February 9, 2018

**Re: Natural Gas Combined Cycle Minor Modification  
Electric Transmission Line and Storm Outfalls Rehabilitation  
NPDES Permit #: PAC060046  
BCCD Project ID #: ESP-00731  
Dawood Project No. 216040.01**

Enclosed, please find revised documents for the above-referenced project updated per comments received from the DEP Chapter 105 permitting review. These documents have been revised to adjust the location of construction fence and supply additional information regarding the areas with equipment and grubbing restrictions. In addition, work associated with outfall 1 has been removed from the project as it is not required and additional notes concerning construction monitoring and waste management have been added.

**B107**

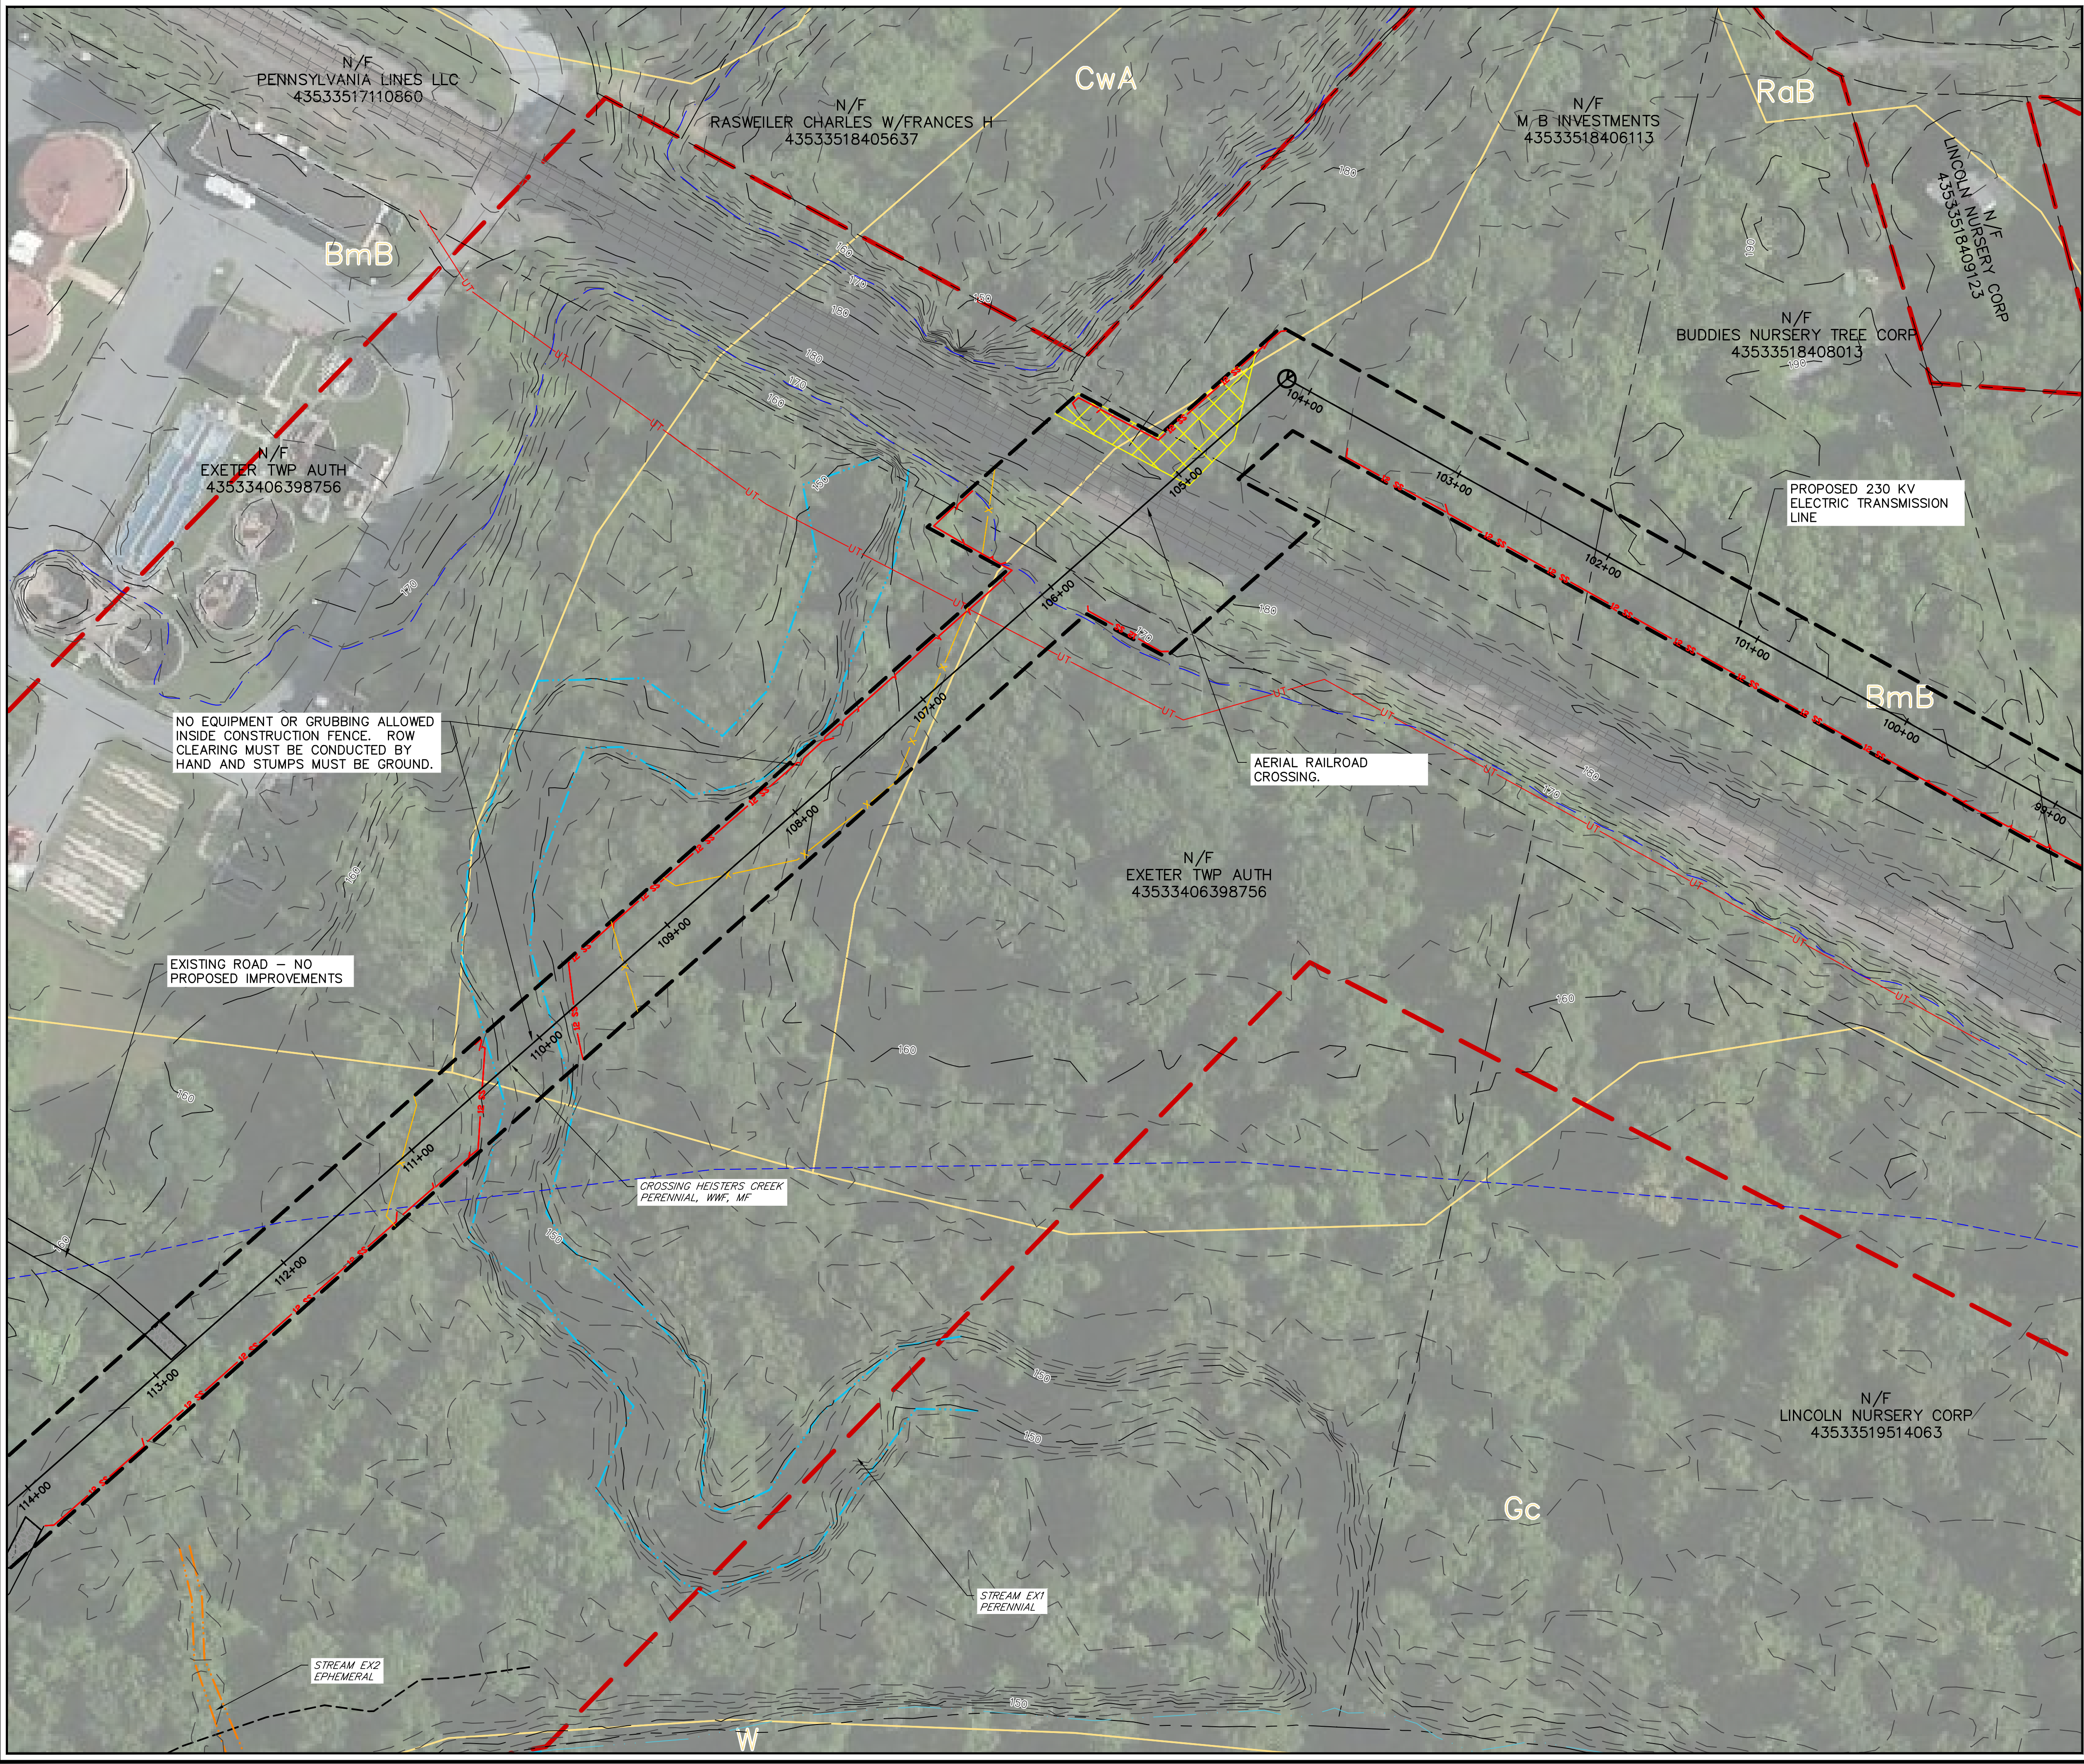
7. ESCP B107 (Page 407)– Additional area has been added where no equipment or grubbing is allowed. Annotation has been added regarding construction fence placement.
8. ESCP B109 (Page 409)– Additional area has been added where no equipment or grubbing is allowed.
9. ESCP B110 (Page 410)– Additional area has been added where no equipment or grubbing is allowed. Annotation has been added regarding construction fence placement.
10. ESCP B113 (Page 413)– Additional area has been added where no equipment or grubbing is allowed. Annotation has been added regarding construction fence placement.
11. ESCP C4 (Page 424)– Additional notes added regarding construction monitoring and waste management on the former armorcast site have been added to plan based on DEP Chapter 105 Review.
